Appendix A Submissions Register

Table 1 The Department Preliminary Assessment Comments

Table 2 Council Submission Comments

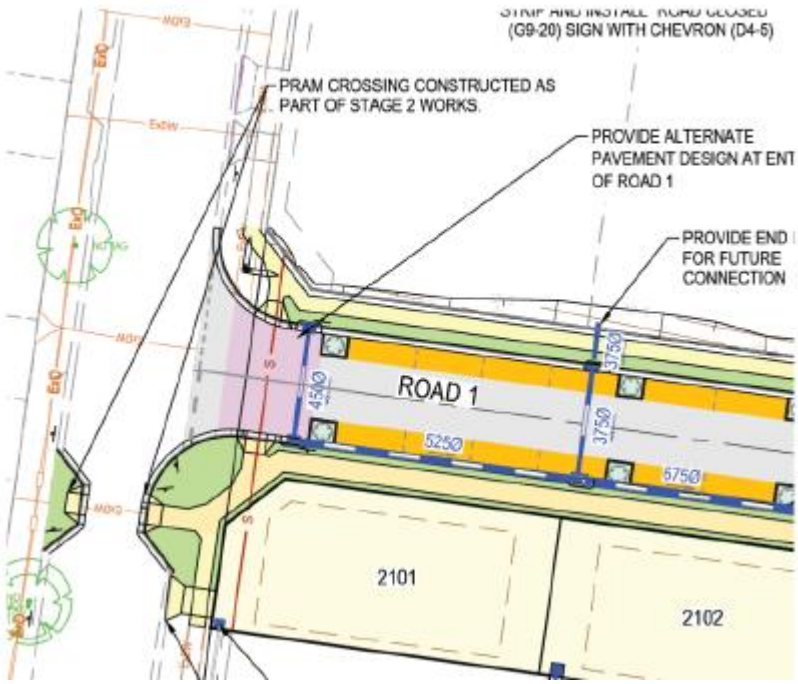
5 Architectural expression and materiality Streetscape building façade design Stages 1 and 2 buildings' elevations excessively rely on repetitive patterns, such as: • Dark colours brick on ground floors. • Limited grey/dark colours cladding or render. • Few architectural elements repeated across façades. • Predominantly flat roofs. Council recommends introducing greater variation in façade elements visible from the street and public domain, including: • Increasing pitched roofs (consistent with prevailing built form across Ashford Ave). • Using lighter coloured bricks similar to the prevailing character of Ashford Avenue. • Avoiding excessive repetition of frontage shapes (e.g., garage entries, square frames). • Incorporating curved lines and distinctive details. • Expanding the palette of materials and colours.	The established residential character along Ashford Avenue includes older dwelling stock with consistent low-scale built form, including simple hip roof forms, brick veneer base and weatherboard façades with repeated element. The bricks are predominantly red with lighter painted weatherboard. More recent, infill developments along Ashford Avenue and in the general locality include two-storey dwellings with modern flat roofs and strong rectilinear forms, in either solid white or grey tones, creating an increasingly mixed character. The proposed development along Ashford Avenue has been intentionally designed to be calm and non-domineering face to the public domain using repetition in facades, roof profiles and material choices. Reviewing Councils RFI and older built stock, the overall brick and colour palette has been reviewed, introducing more reddish coloured bricks, and a lighter colour palette. The overall materiality has introduced more face brick to better tie into the existing streetscape. This materiality and colour palette

Comment	Response
These measures will improve visual interest, reduce monotony, and create a more engaging streetscape that reflects local character and enhances the public domain experience.	is carried into Stage 2 and introduces a greater diversity of architectural treatment through hipped roof forms, lightweight cladding, modulation, screens and accent colours, providing additional variation and articulation across the development. These measures collectively respond to Council's recommendations by reducing uniformity, increasing visual interest, and reinforcing compatibility with the desired future character, while remaining consistent with the architectural controls of the WSU Milperra Site-Specific DCP.
Housing diversity Stages 1 and 2 offer mainly 3- and 4-bedroom detached dwellings, limiting housing provision diversity. Council recommends that future stages include a broader mix permitted in R1 zone (e.g., attached dwellings, multi dwelling housing, shop-top housing) to meet community needs and reinforce park edges with continuous frontages (e.g., Central Park lots 6101–6114, 4406–4413, 5201–5210). Mixed-use typologies near parks will also support activation and improve street character (refer previous comment 5.1).	Housing diversity is being explored under SSDA 2. As stated in the SEARs Request for SSDA 2, the balance of the housing will be delivered on the site under this future application. The Applicant is exploring the provision of multi-dwelling housing and dual occupancies in the future subdivision of the superlots proposed under SSDA 1.

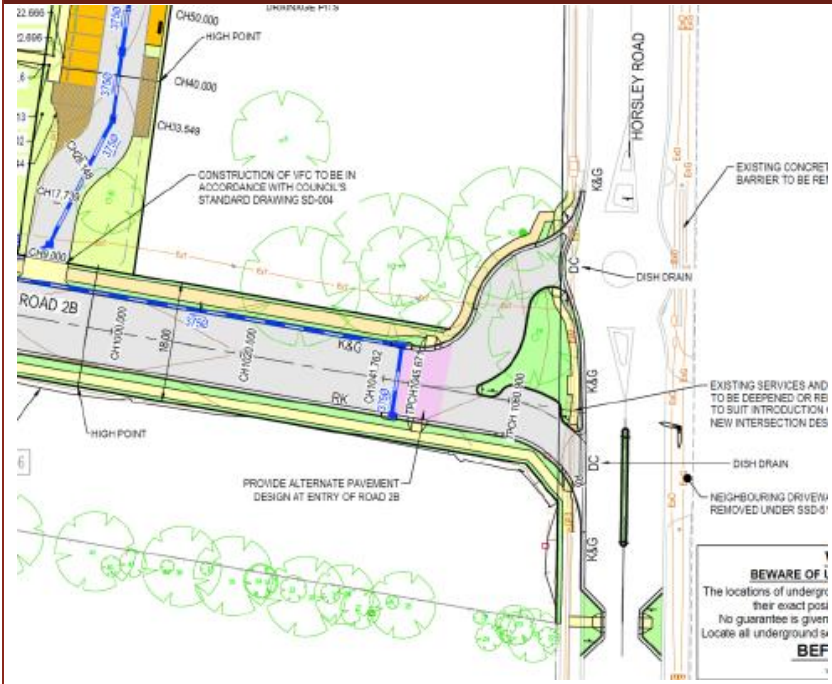
Asset Systems	
Roads: “Standard Flexible Pavement” detail specifies sandstone subbase. Subbase needs to be DGS20 road base. Sandstone is not acceptable. Proposed pavement thicknesses by “Geotech Testing Pty Ltd” are acceptable	The pavement details have been updated in the proposed civil plans (refer Appendix B).
Stormwater General – All proposed works and stormwater design shall be in accordance with Canterbury-Bankstown Development Control Plan 2023, ARR 2019 version 4.2 and relevant Australian standards. Refer to relevant sections of the DCP including: • Chapter 3.1 Development Engineering Standards, • Chapter 2.2 Flood Risk Management • Development Engineering Standards Guide	All stormwater infrastructure proposed in SSDA1 complies with the referenced standards. This is confirmed in the Civil Engineering Design Report (refer Appendix G).
Stormwater • Provide DRAINS and MUSIC model for pre and post-development scenarios • The concept stormwater layout shown in Civil Engineering Plans are noted to be indicative only. Detailed design shall incorporate the following comments from the pre-DA stage:	A Drains and MUSIC model is provided at Appendix P and Q respectively. This is noted. Detailed design plans at the construction certificate stage will incorporate comments identified from the pre-DA stage.

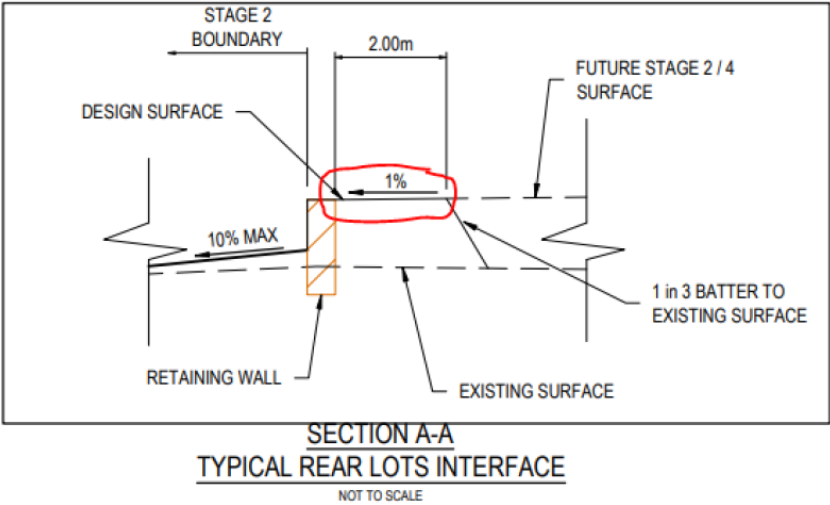
26. A site plan that shows the entire site and road network is to be provided with the zoning map overlaid for assessment. A preliminary review appears that the location of Road 2B accessing of Horsley Road is located partially within the C2 Environmental Conservation zone and E1 Local Centre zone. The objectives and controls within the CBDP 2023, Chapter 11.13, Section 3.4 require that the development of the site enhance and conserve existing canopy cover and retain trees. A concern is raised over the placement of this road within the conservation zone. The road alignment should be reviewed and shifted south to ensure that the conservation zone is not impacted by the access into the development site. The access shown to Horsley Road is unorderly and at this stage the access design would not be supported. It is unclear how the design is operationally the best solution for accessing the site along Horsley Road. The design should be revised, and the road alignment shifted to ensure the C2 zone is not impacted unnecessarily. Any access for the development needs to be detailed in a Traffic Impact Assessment submitted within any DA lodgement. The Traffic Impact Assessment must evaluate alternative treatments	This comment was satisfied prior to lodgement of the SSDA. Please refer to the zoning overlay map submitted with SSDA 1.

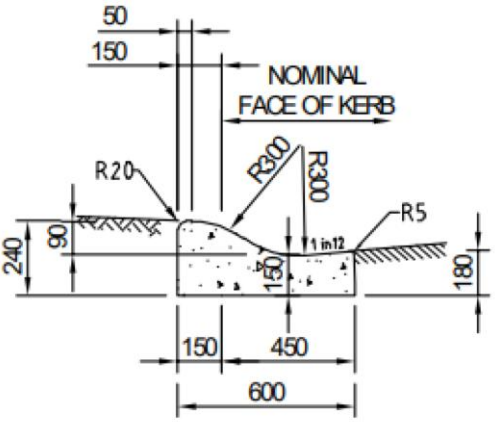
34. The architectural plans for dwellings on site must ensure that they demonstrate the existing natural ground level in accordance with the updated survey required, the proposed natural ground level based on the civil works proposed within the DA to ensure complete and accurate assessment of building height, visual privacy and solar access and impacts on adjoining properties.	This comment was satisfied prior to lodgement of the SSDA.

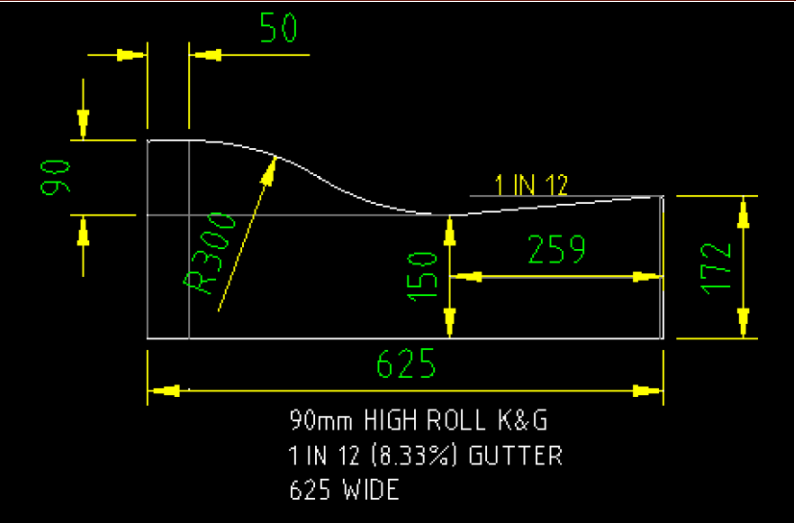
Biodiversity	
36. Figure 5 (Layout of the project) in the Biodiversity Development Assessment Report (BDAR) proposes the removal of vegetation outside of the subject land that has not been mapped or considered in the BDAR. This vegetation is located outside of the southern boundary of the subject land adjacent to the M5. Given	This comment was satisfied prior to lodgement of the SSDA. Please refer to the updated BDAR at Appendix D.

Comment	Response
the location of this vegetation outside of the subject land, impacts to this vegetation could be avoided through design refinements.

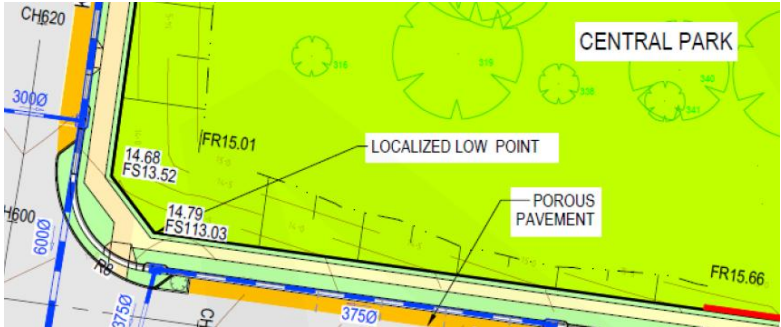
37. Biodiversity Assessment and Mitigation Hierarchy a) The BDAR does not adequately demonstrate that the mitigation hierarchy has been applied, specifically in relation to avoidance and minimisation of impacts. b) The BDAR attempts to justify avoidance on the basis that the north-eastern portion of the site zoned C2 – Environmental Conservation was excluded from development at the rezoning stage. Council notes that the Accredited Assessor has previously been advised and agreed that the C2 zone cannot be considered avoidance in subsequent assessments, as the protection of this land was a requirement of the rezoning and its use for residential development is prohibited. c) Despite the above, the BDAR continues to present the C2 Environmental Conservation zone as an area of avoidance. This approach is inconsistent with the Biodiversity Assessment Method (BAM) and the Biodiversity Conservation Act 2016 (BC Act). The BDAR must be revised to: a. clearly identify the C2 zoned land, b. exclude this land from being treated as avoidance, and c. ensure no additional impacts are proposed within this zone. d) Council also notes that the current proposal includes impacts to land zoned C2 – Environmental Conservation, which is not accepted. These impacts must be removed from the proposal. e) With the C2 zoned land excluded, the BDAR must then identify the areas of Cumberland Plain Woodland proposed for retention and removal. f) Council further notes that the Accredited Assessor has submitted multiple environmental assessments that are inconsistent with the BAM and the BC Act. g) No genuine attempt has been made to retain vegetation within the proposed subdivision. Vegetation shown for retention within the RE1 – Public Recreation zone is limited to planted native vegetation and does not comprise Cumberland Plain Woodland. Accordingly, reasonable avoidance has not been demonstrated. h) Council rejects the argument put forward in the BDAR that the R1 – General Residential zoning justifies the removal of vegetation, including Cumberland Plain Woodland. The provisions of the BC Act prevail over Part 4 of the Environmental Planning and Assessment Act 1979 to the extent of any inconsistency. As such, the zoning of the site cannot override the requirement to demonstrate reasonable avoidance under the BAM and BC Act. i) It is clear from the plans provided that much of the vegetation proposed for removal could be retained under the current design and further design amendments could allow for the retention of further vegetation. These are considered avoidable impacts.	This comment was satisfied prior to lodgement of the SSDA. Please refer to the updated BDAR at Appendix D.

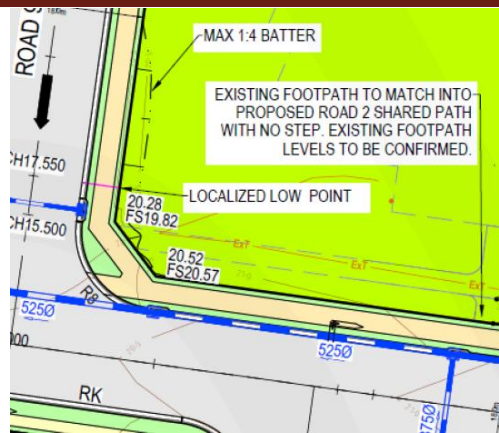
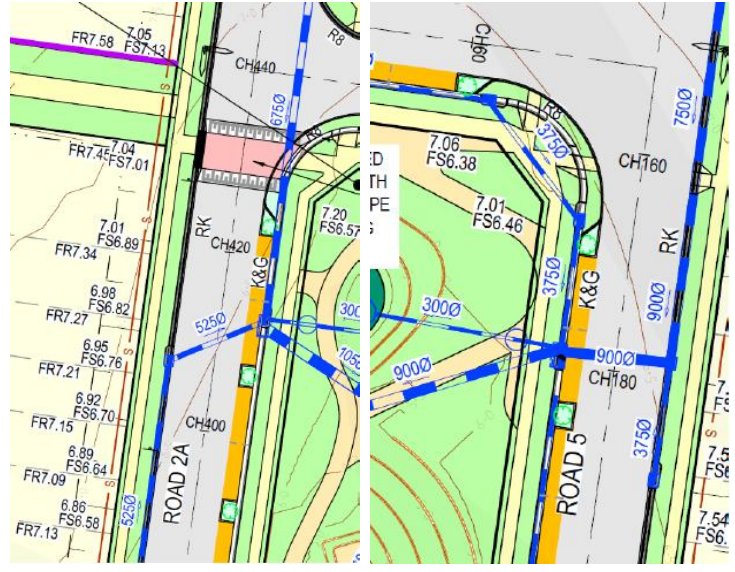
44. VFC layout plan shall be provided for the proposed VFCs along rolled kerb on Road 2A which indicates the following: - o VFC widths at the property boundary - o Clearances from proposed infrastructure within the future Road Reserve in accordance with Council Standard Drawing S-004 - o Minimum 1.0m offset from side property boundaries to edge of VFC - o Minimum one (1) on-street parking space of 5.5m length per lot frontage	This comment was satisfied prior to lodgement of the SSDA. VFC's are shown in the Layout Plan for Stages 1 & 2 (sheets 19-21). Drawing 051-053 of the civil plans at Appendix B .

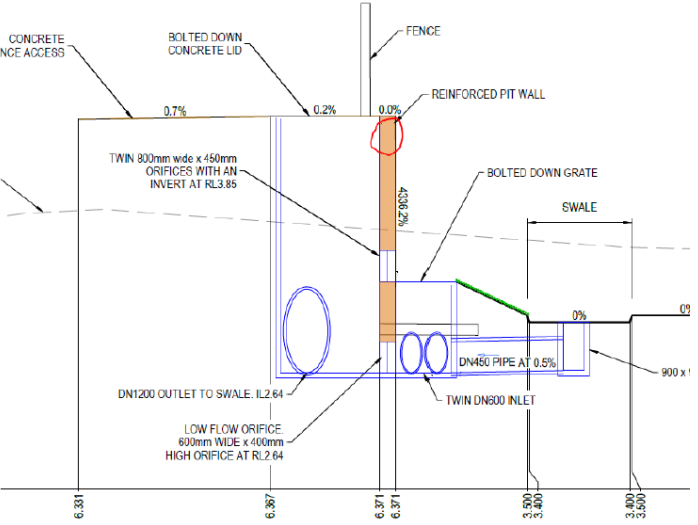
56. Details of stormwater management system and off-street parking design for proposed Child Care Centre shall be provided which demonstrates compliance with relevant Australian Standards and Council's Development Engineering Standards.	This comment was satisfied prior to lodgement of the SSDA. Provision for stormwater drainage has been provided for the childcare lot and will be coordinated with the childcare alterations and additions proposed under SSDA 2.
Stage 7
